Pilar Aberasturi
Senior Planner, Urban Assessments

Figure 19: Shadow cast by PPR (blue). Retention of solar access for residential properties along Abercrombie begins by 11am mid winter.

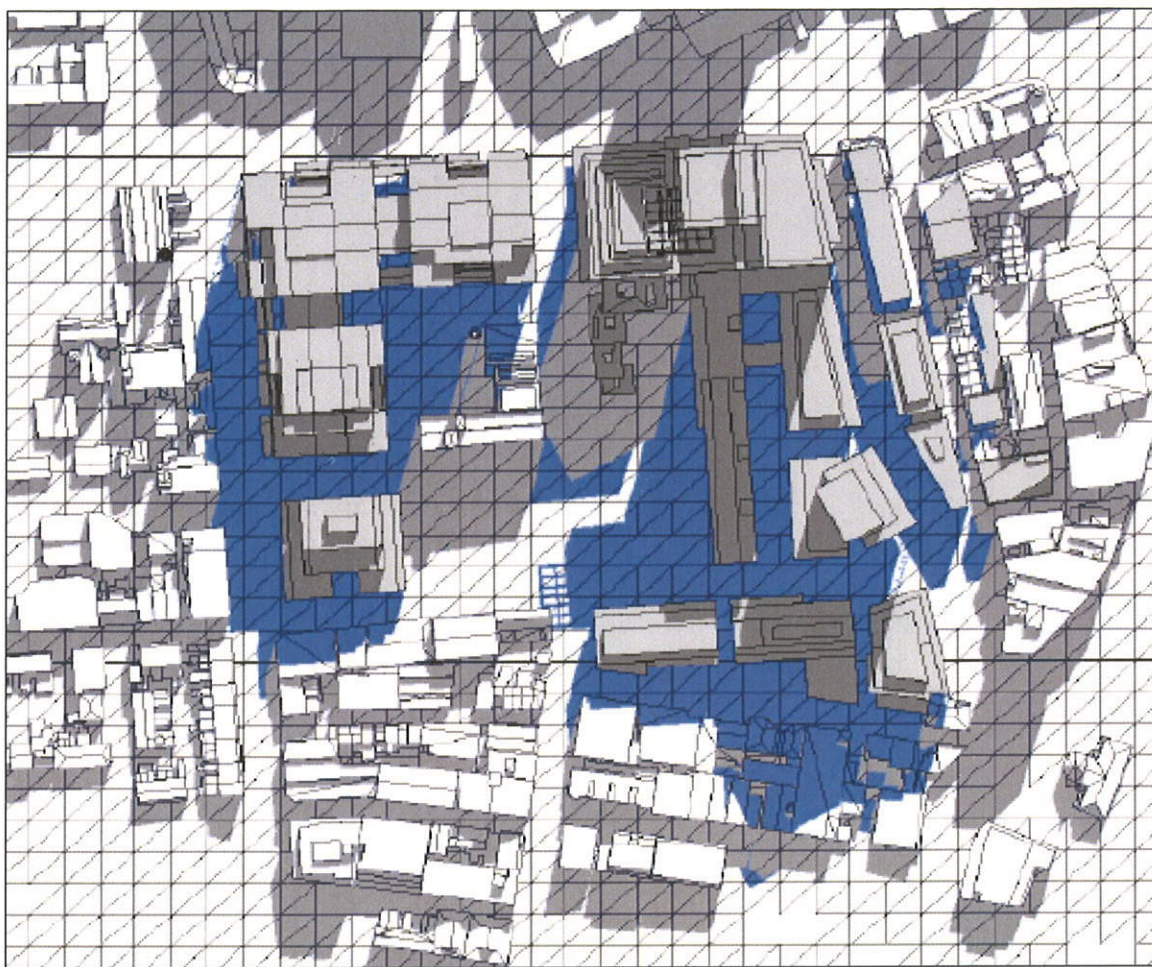
The shadow cast onto neighbouring properties to the West will be greater than that approved up to 11am during mid winter and mid March.

However, from 11am the majority of all properties will retain their existing solar access. No overshadowing will occur between 12.00pm and 2.00pm during midwinter as a consequence of this modification. This generally complies with the recommendations of the EAP Recommendation 4.

While there is an additional morning overshadowing impact, the shadows cast are not expected to unduly prejudice the amenity of adjoining residential properties. In the context of this dense, city edge, urban environment the overshadowing impacts from the modification proposal are considered to be reasonable. Refer to **Figures 18** and **19** for a comparison of approved and PPR shadows cast at 11am midwinter. Affected properties are located along the western edge to the site.

Figure 21: PPR shadow at 1pm midwinter. Shadows cast extend further south.

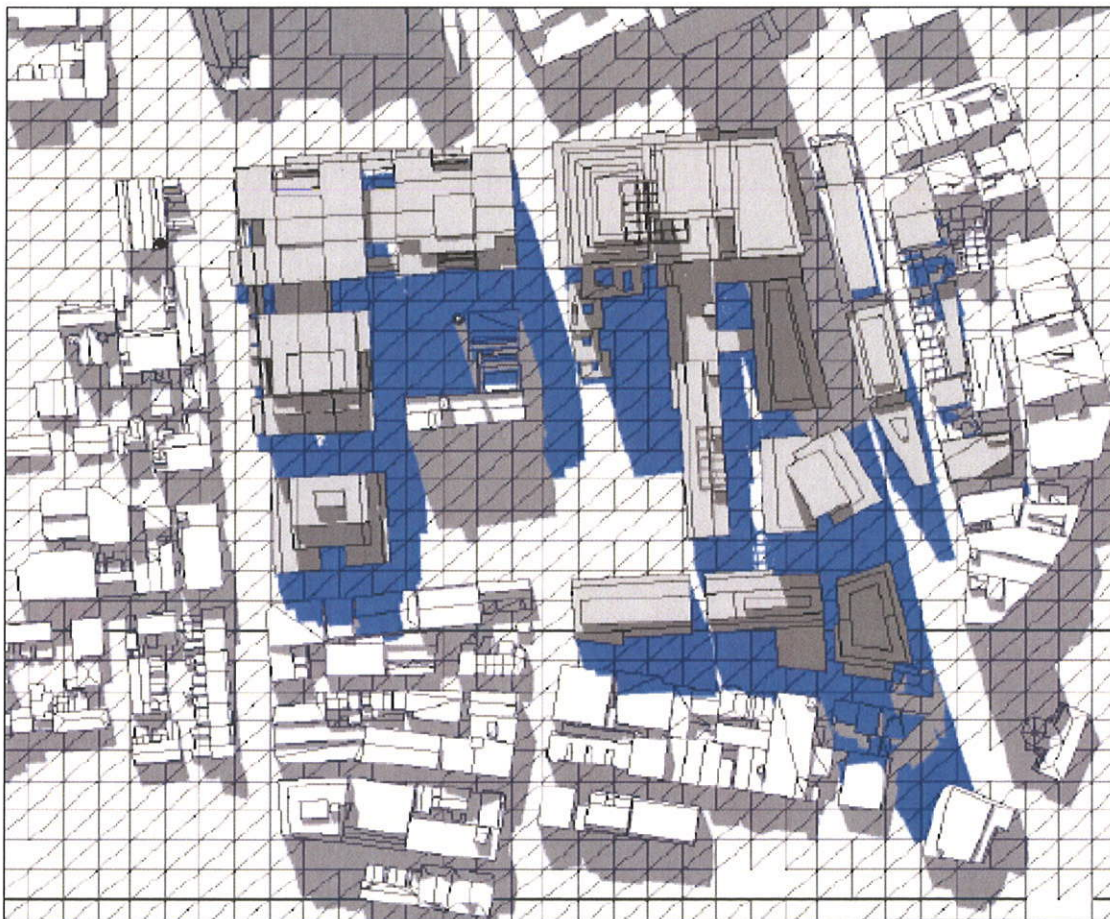
The shadows cast by the Modified proposal towards Wellington Street are greater during midwinter than the approved Concept Plan. However, the shadows cast at mid March are less than the approved Concept Plan, throughout all times of the day. Real gains for Wellington Street residents are experienced in mid March by the removal of bulk sited along the Wellington Street edge and building breaks along Block 11.

To the east including Regent Street, shadows cast by the modification increase overshadowing of residential properties between 12 – 2pm midwinter, however direct sunlight access is maintained during morning hours to these affected properties. Further, slight improvement in shadows cast from that approved results from retention of Block 10.

On balance, while there is additional overshadowing during midwinter, the solar access gains during mid March are a considerable improvement. Refer to **Figures 20 and 21** for a comparison of approved and PPR shadows cast at 1pm midwinter. Affected properties are located along the southern and eastern edges to the site.
